**Recommended Amendments to the
2015 International Residential Code**
North Central Texas Council of Governments Region

The following sections, paragraphs, and sentences of the *2012 International Residential Code* are hereby amended as follows: Standard type is text from the IRC. Underlined type is text inserted. ~~Lined through type~~ is deleted text from IRC. A double asterisk at the beginning of a section identifies an amendment carried over from the 2012 edition of the code and a triple asterisk identifies a new or revised amendment with the 2015 code.

****Figure R602.6.1; delete the figure and insert the following figure:**

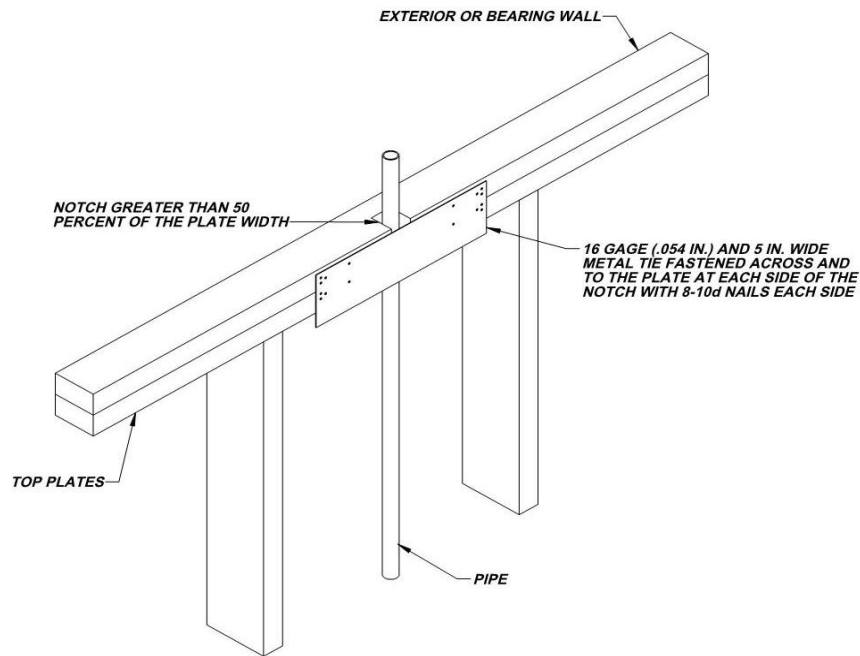
R602.6.1 Drilling and notching of top plate. When piping or ductwork is placed in or partly in an exterior wall or interior load-bearing wall, necessitating cutting, drilling or notching of the top plate by more than 50 percent of its width, a galvanized metal tie not less than 0.054 inch thick (1.37 mm) (16 Ga) and ~~4 ½ inches (38 mm)~~ 5 inches (127 mm) wide shall be fastened across and to the plate at each side of the opening with not less than eight 10d (0.148 inch diameter) having a minimum length of 1 ½ inches (38 mm) at each side or equivalent. Fasteners will be offset to prevent splitting of the top plate material. The metal tie must extend a minimum of 6 inches past the opening. See figure R602.6.1. {remainder unchanged}

(Amendment to 2012 IRC carried forward to 2015 IRC also provides additional assurance of maintaining the integrity of the framing by spreading the nailing pattern.)
